Access Compliance Report Public Rights-of-Way (Curb Ramps)

Main Street: ETHEREAL_RD Cross Street: SIENNA_PKWY Location: N

ADA ID: RPRK211104123254 Ramp Type: Type 1 - Perpendicular Initial Pass/Fail: Fail Overall Compliance: No Severity Score: 2

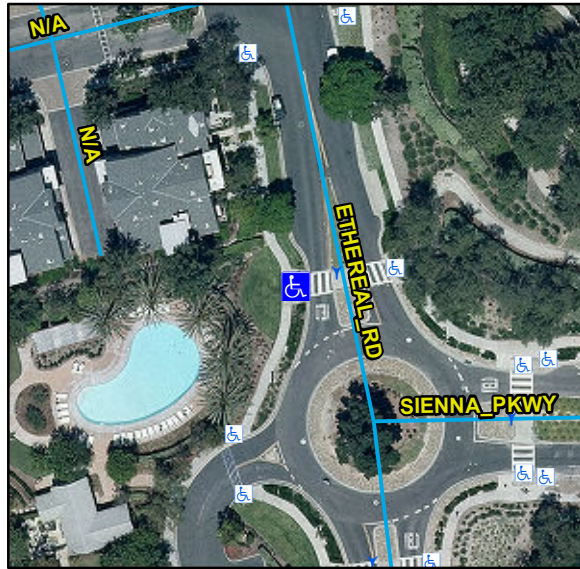
R204.3, R304.5.3, STD 1115

Compliance	Description	Data	Compliance	Description	Data
N/A	Ramp Length (in)	94	N/A	Flare Type LT	
Yes	Ramp Width (in)	48			N/A
Yes	Ramp Run Slope (%)	8.3	N/A	Flare Slope LT (%)	N/A
No	Ramp Cross Slope (%)	2.4	N/A	Flare Traversable LT	N/A
N/A	Landing Present	N/A	N/A	Flare Type RT	
N/A	Landing Length (in)	N/A			N/A
N/A	Landing Width (in)	N/A	N/A	Flare Slope RT (%)	N/A
N/A	Landing Run Slope (%)	N/A	N/A	Flare Traversable RT	N/A
N/A	Landing Cross Slope (%)	N/A	N/A	DWS Provided	N/A
N/A	Landing Movement Obstructed?	N/A	N/A	DWS Contrast	N/A
	Landing Movement Type	N/A	N/A	DWS Length (in)	N/A
N/A	Landing Shared	N/A	N/A	DWS Full Width	N/A
N/A	Clear Space	N/A	N/A	DWS Offset Left (in)	N/A
N/A	Clear Space To Crosswalk (in)	N/A	N/A	DWS Offset Right (in)	N/A
N/A	Marked Crosswalk 1	Yes	N/A	Marked Crosswalk 2	N/A
	Crossing 1 Direction	E		Crossing 2 Direction	N/A
	Marked Crosswalk 1 Width (in)	144		Marked Crosswalk 2 Width (in)	N/A

Remove & Replace Entire Ramp.
